SUB-COMMITTEE ON DANGEROUS
GOODS, SOLID CARGOES AND
CONTAINERS
18th session
Agenda items 5 and 8

DSC 18/WP.3
18 September 2013
Original: ENGLISH

DEVELOPMENT OF MEASURES TO PREVENT LOSS OF CONTAINERS
REVISION OF THE GUIDELINES FOR PACKING OF CARGO TRANSPORT UNITS

Report of the working group

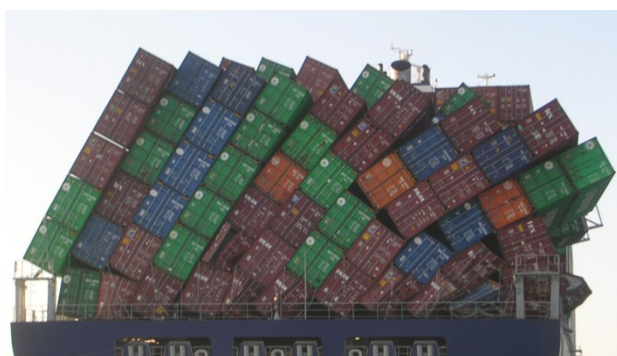
Figure 1.15, paragraphs 5.4 and 5.5 should be deleted and replaced by the following text:

Inadequately packed containers or misdeclared container weights declaration may cause container stacks to collapse.

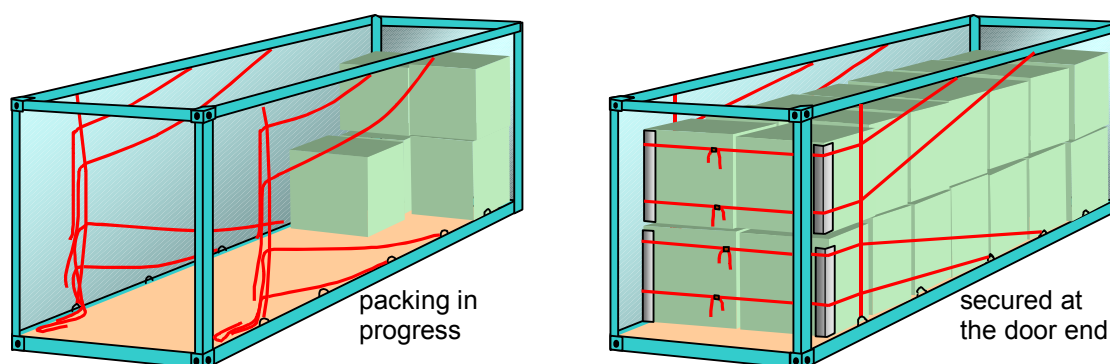
Figure 14.20: it shows a modular system of a certain provider of lashing material which has obviously been copied from advertising material. The CTU Code should not show products of certain providers but illustrate the principle of cargo securing. Therefore, it should be replaced by the following illustration:

new Figure 14-22

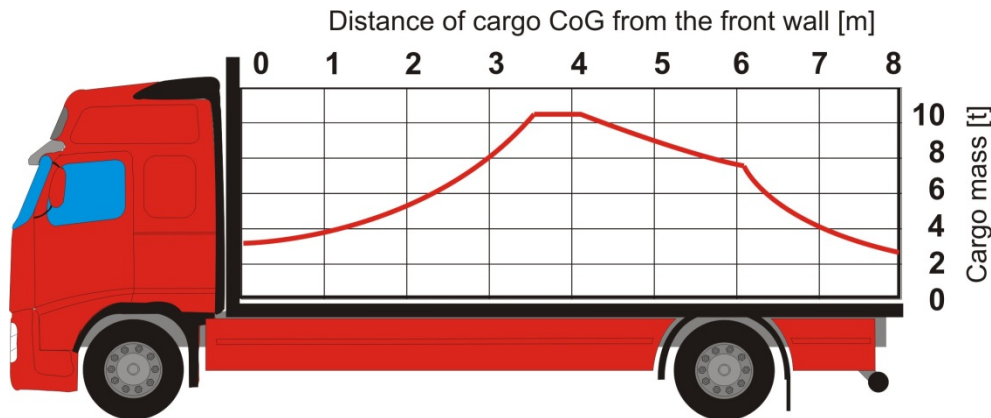
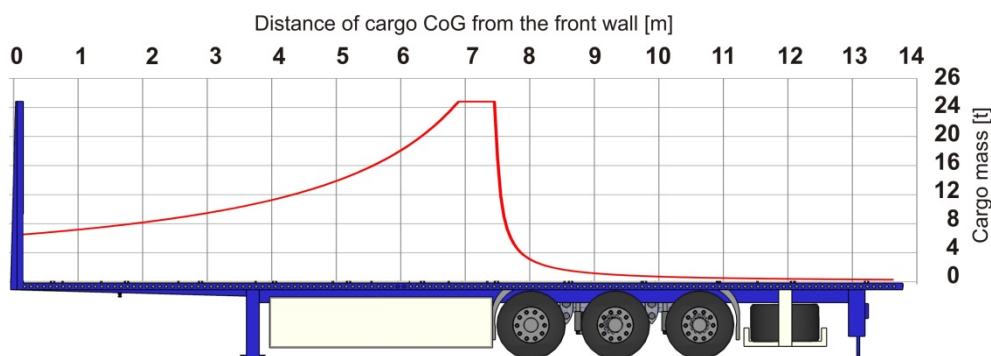
Paragraph 3.1.7: Figure 14-22, and Figure 14-23: replace figures with following figures:

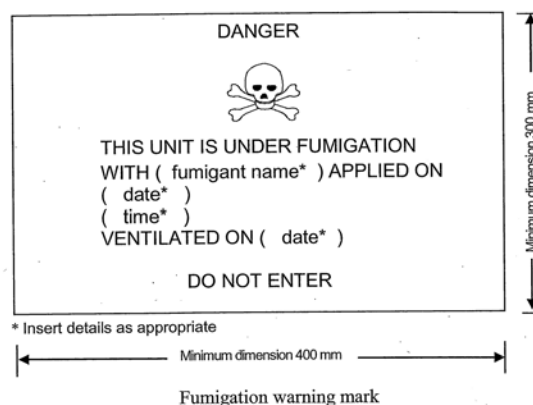
Fumigation: the fumigation mark is regulated in the regulations for the transport of dangerous goods. It would be best not to have detailed description of the fumigation mark in the CTU. Delete 3.2 and 3.3 and replace it with the following:

"3.2 The fumigation mark shall comply with the relevant dangerous goods regulations. Hereafter is the fumigation mark as in the 18th revised edition of the United Nations Model Regulation."
